APPLICATION FOR MODIFICATION ASSESSMENT REPORT

Application Number:	Mod2025/0018
Responsible Officer:	Phil Lane
Land to be developed (Address):	Lot 5B DP 158658, 58 Beaconsfield Street NEWPORT NSW 2106 Lot 6 DP 1096088, 56 Beaconsfield Street NEWPORT NSW 2106 Lot 7B DP 162021, 54 Beaconsfield Street NEWPORT NSW 2106
Proposed Development:	Modification of Development Consent DA2023/1869 granted for Demolition works and construction of a Residential Flat Building including the consolidation of 3 lots into 1 lot
Zoning:	R3 Medium Density Residential
Development Permissible:	Yes
Existing Use Rights:	No
Consent Authority:	Northern Beaches Council
Delegation Level:	NBLPP
Land and Environment Court Action:	No
Applicant:	Jak Newport Pty Ltd

This application seeks consent to modify DA2023/1869 for the demolition of existing dwellings, consolidation of three lots into one, and construction of a 13-unit residential flat building at 54-58 Beaconsfield Street, Newport.

Figure 1 - Section 02 from Architectural Plans

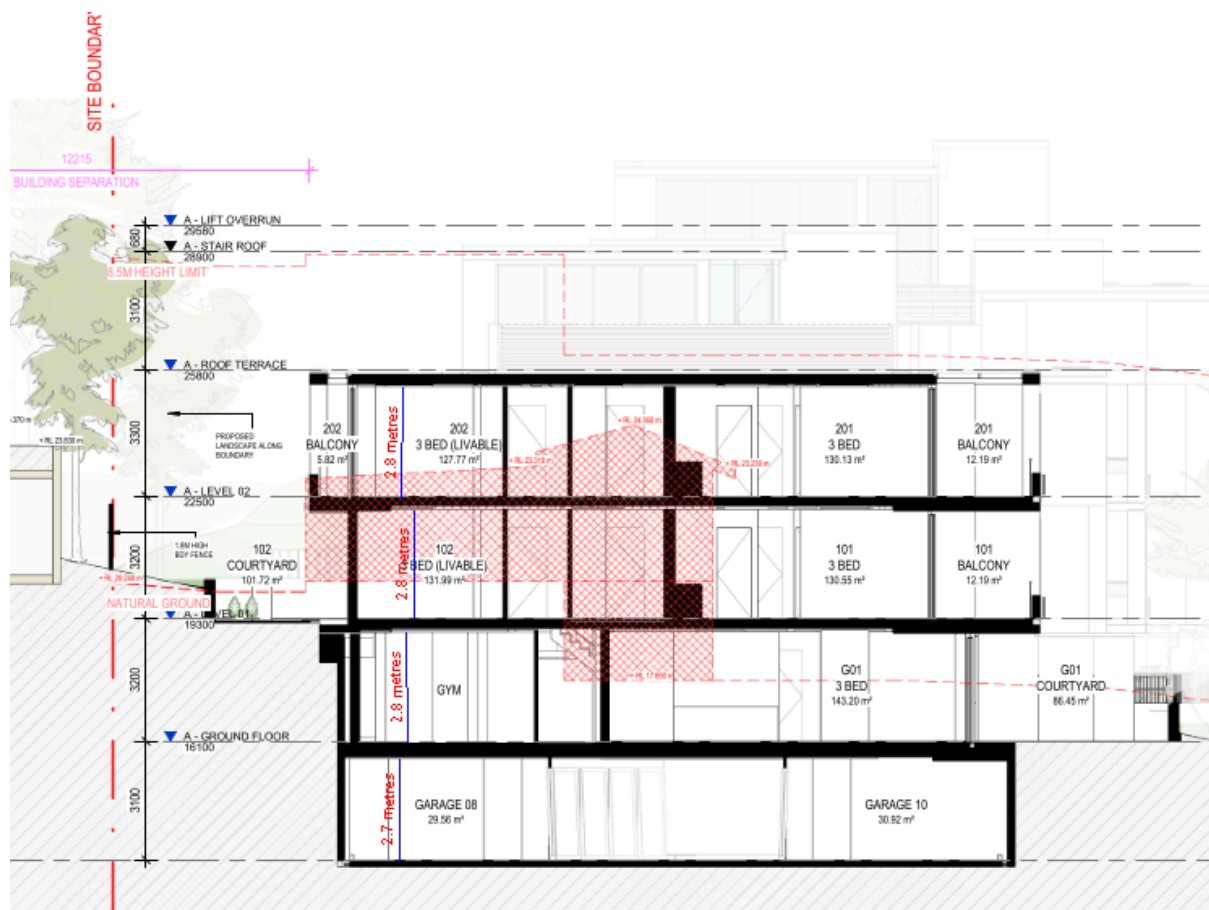
The submissions raised concerns that the proposal does not comply with building height due to lift overruns protruding the height plane due to headroom required for the lift overruns and also increases to floor to floor heights.

Comment: The majority of the building's footprint and envelope complies with the building height development standard. The areas of non-compliance are limited to the eastern and western lift overruns, the eastern stair enclosure, portions of planter boxes surrounding the communal open spaces on the rooftop, and the southern awning over the balcony of Unit 204. Notably, the lift overruns provide necessary access—including disability access—to the rooftop communal open spaces, which is a requirement under the Apartment Design Guide (ADG).

Additionally, the increased floor-to-floor heights are intended to provide a flush transition between internal living spaces and balconies/communal areas, while still achieving a clear ceiling height of 2.7 metres in all habitable rooms. This results in a floor-to-floor height of 3.2 metres between the Ground and Level 01 and from Level 01 to Level 02, and 3.3m between Level 02 and the roof terrace.

Given the above, the proposed lift headroom and floor-to-floor heights are considered reasonable. They support a high level of internal amenity for future occupants without resulting in any significant adverse visual or amenity impacts on adjoining properties or the Beaconsfield Street streetscape.

Figure 4 - Height blanket diagram for MOD2025/0018 from southwest perspective (provided by the applicant)

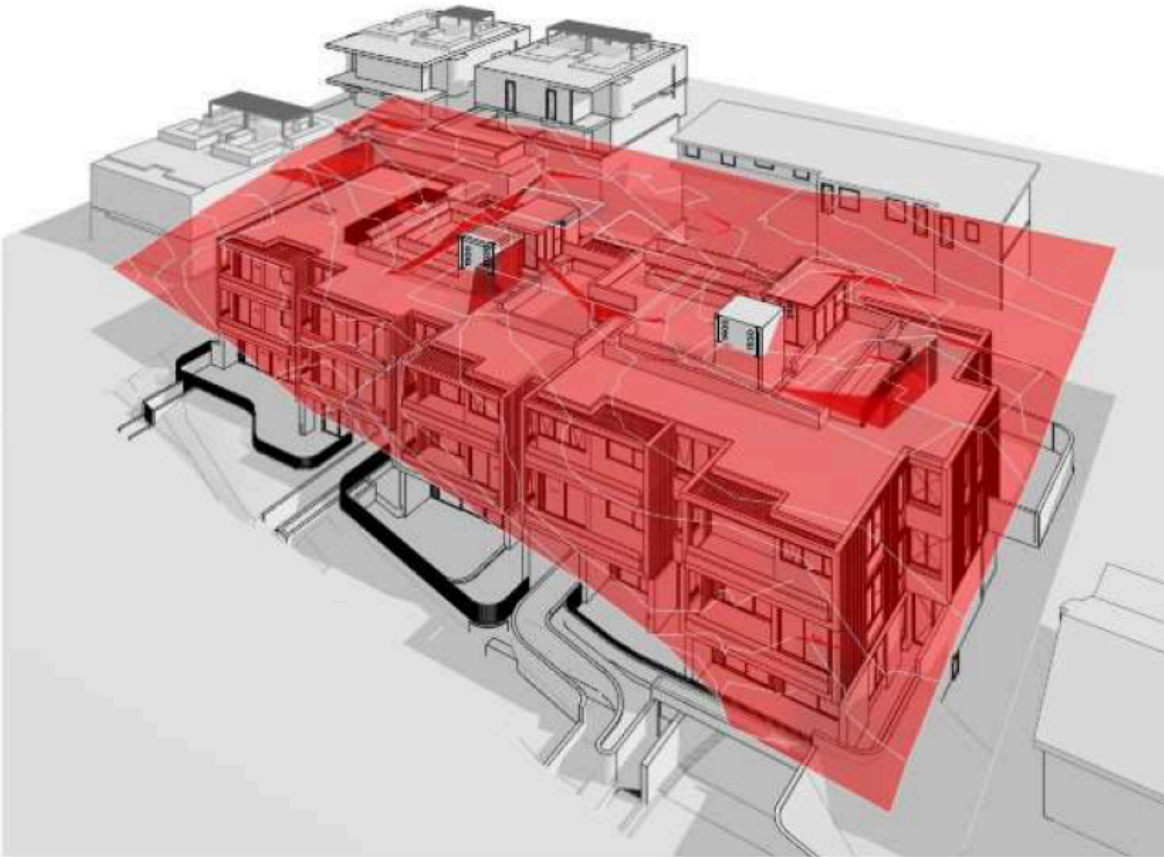
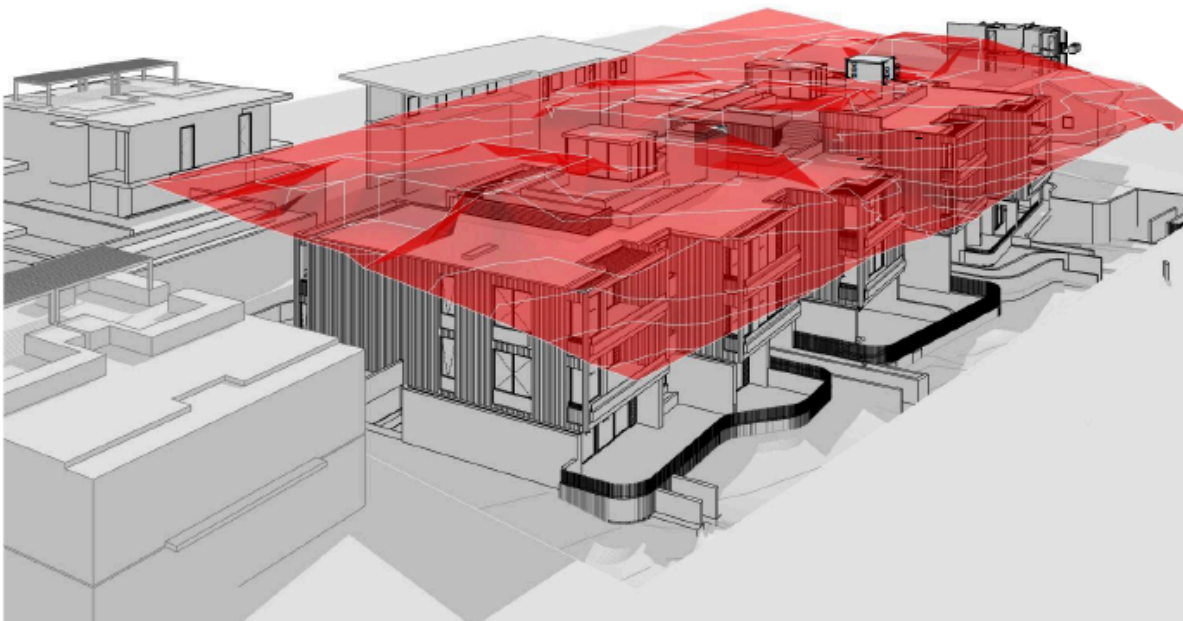
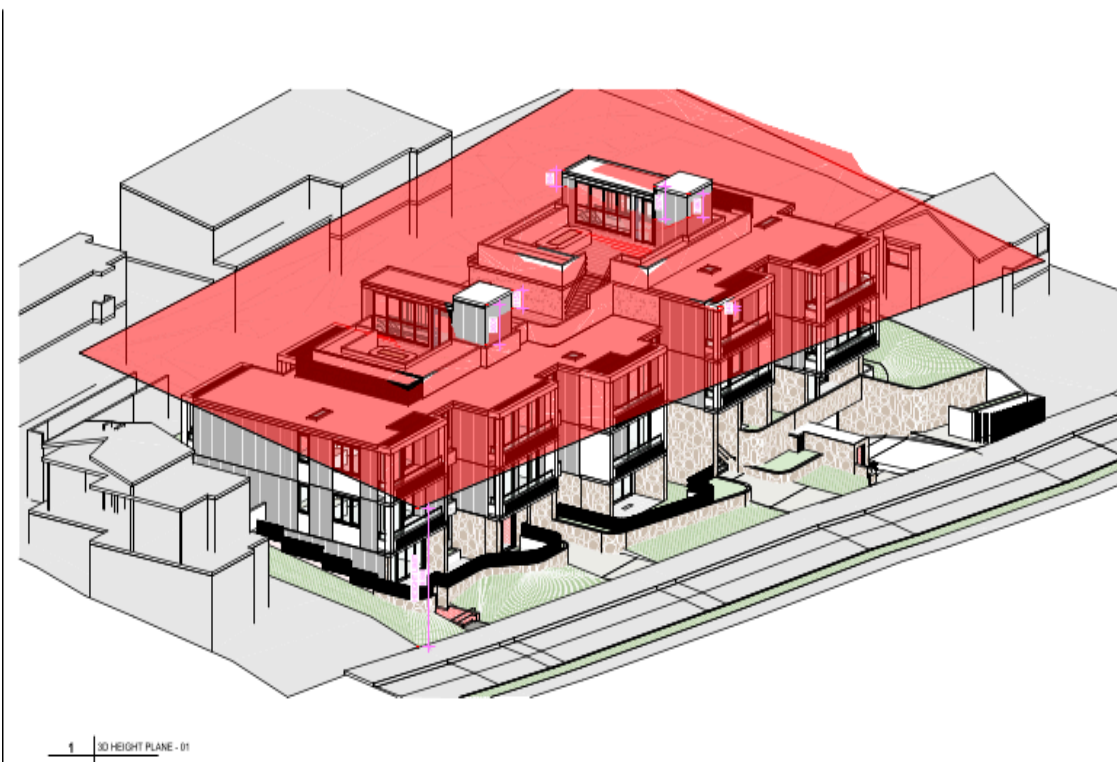
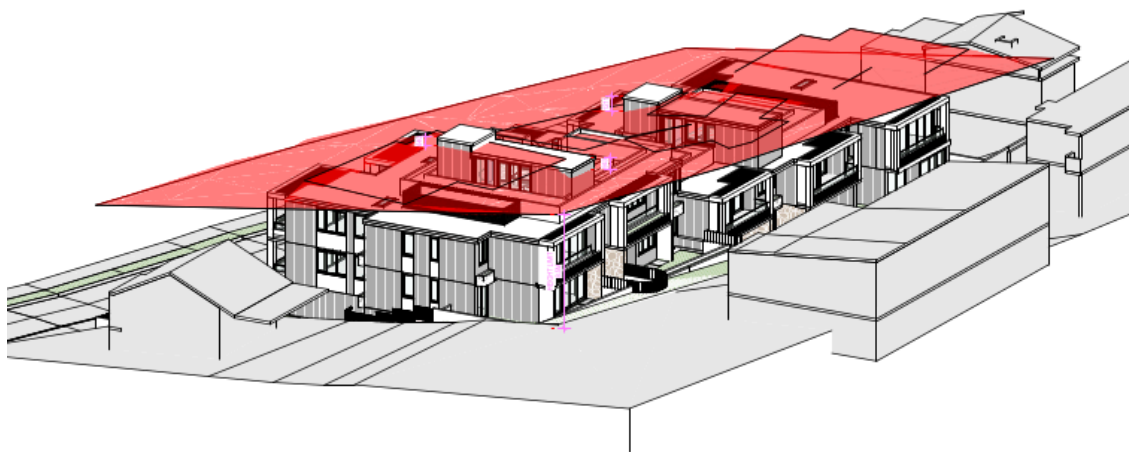
Original Approved Height	Breach Over 8.5m	Proposed Height	Breach Over 8.5m	Difference
Western Lift Overrun	10.52m*	2.02m	11.1m	2.6m	+ 0.58m
Eastern Lift Overrun	10m**	1.5m	10.574m	2.074m	+ 0.574m
Eastern access lobby	8.4m	-	9.384m	0.884m	+ 0.984m
Awning over balcony for Unit 204/ Planter boxes	8.1m	-	8.7m	0.2m	+ 0.6m

Table 1 (above) has been provided to clearly differentiate between the approved building heights under DA2023/1869 and the proposed heights under the current modification application MOD2025/0018. The key changes are as follows:

- The eastern access stair lobby has increased by 0.884m, resulting in a new height of 9.384m.
- The planter boxes and awning over the balcony of Unit 204 have increased by 0.2m, reaching a maximum height of 8.7m.

These amendments represent minor increases to rooftop structures and elements, with all height breaches located towards the centre of the site and away from the building's outer façades—with the exception of the awning over Unit 204. The potential impacts of these changes are addressed in detail throughout this report.

It is considered that the applicant has satisfactorily demonstrated that compliance with Clause 4.3 of the *Pittwater Local Environmental Plan* (PLEP) is unreasonable or unnecessary in the circumstances of this application. The variation has been appropriately justified on the basis that the objectives of Clause 4.3 are achieved, notwithstanding the numerical non-compliance.

Comment: Having regard to the circumstances of the case, it is considered that there are sufficient environmental planning grounds to justify the contravention of the height development standard in this instance. The proposed variation results in a built form that remains compatible with both the existing and desired future character of the locality. It does not give rise to any unreasonable amenity impacts and continues to achieve key planning objectives relating to urban design, landscaping, and view sharing.
